Comments on originally proposed design received at February 6th hearing

REVISED
28 Feb 2020

Lesley University
Burnham Hall

Proposed Fenced Enclosure for HVAC Equipment

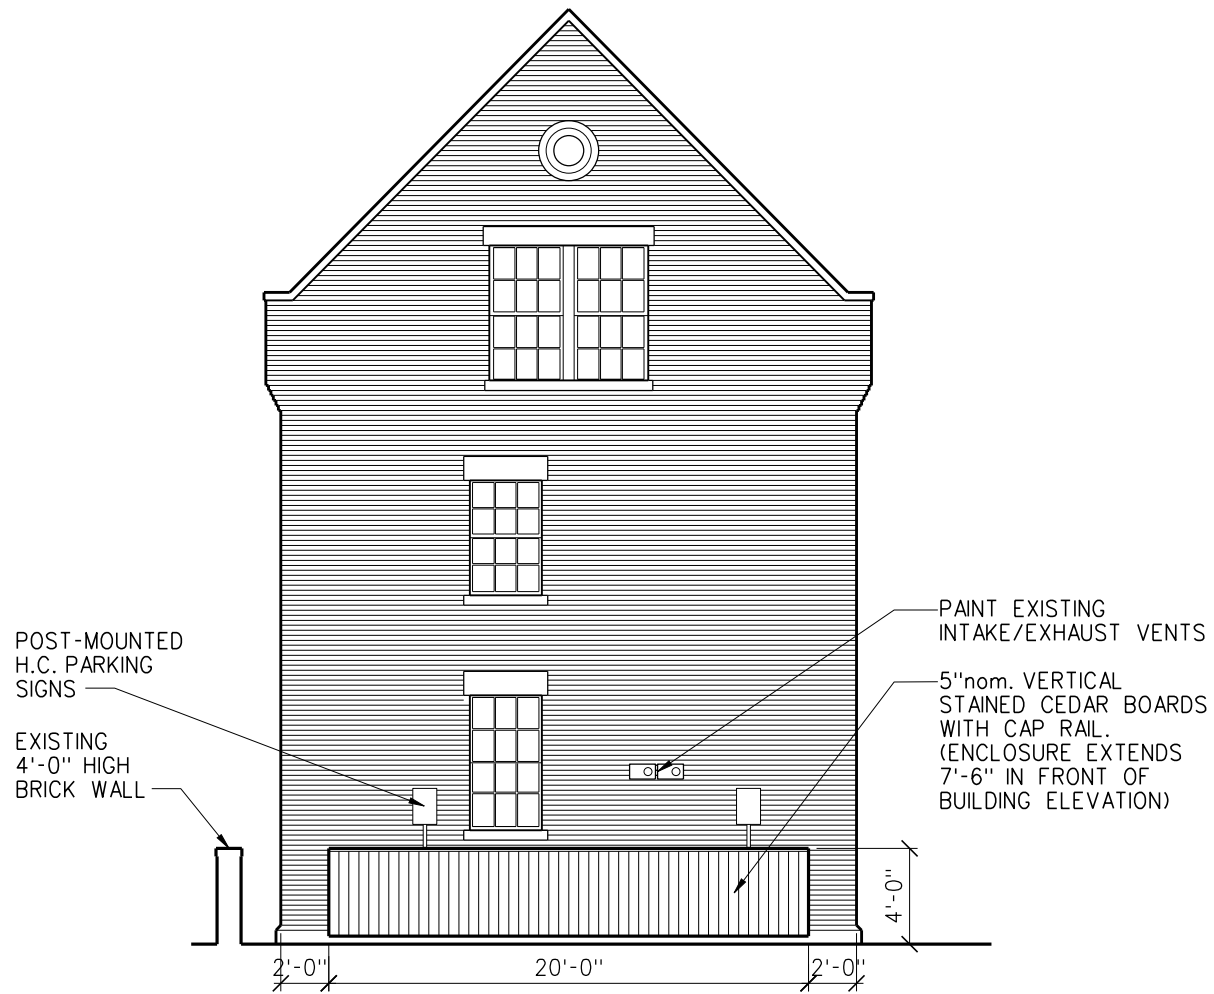
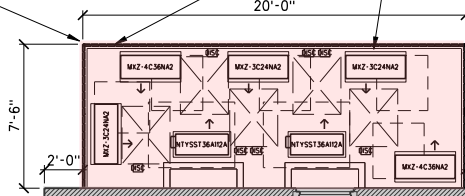
- The 7'-6" height was too massive.
- It was unfortunate that the fence obscured the lower half of the 1st floor window.
- The design did not relate to the adjacent low, brick wall in height or materiality.
- The paint color of the fence should not attempt to match the color of the brick.
- Some Commissioners suggested that brick would a better selection for the material of the enclosure; however, others noted that matching the weathered brick of the original building or the adjacent low wall would be difficult.

- The height of the proposed enclosure is reduced to 4'-0".
 - In order to reduce the height, there will be seven smaller AC units inside the enclosure (instead of five taller units). Lesley plans to install three of the units now; the remaining four units will be installed in future projects.

- The equipment will be used for cooling only, eliminating the need for snow stands, and units will sit on pads placed on grade. The overall height of the units will be approximately 37" high.

- The footprint of the proposed enclosure remains the same: 20'-0" x 7'-6".
- The 4'-0" height of the enclosure will align with the height of the adjacent low brick wall.

- The lower half of the double-hung window will not be obscured.
- The proposed material of the fence remains wood, but the wood will be stained gray (similar to the stone at the adjacent Reed Building).

- The existing stainless steel intake/exhaust vents for the existing condensing boilers will be painted to blend with the brick.
- Required signage for accessible parking spaces will be mounted to posts just inside the fence. (The height of the signs is mandated by ADA Standards.)
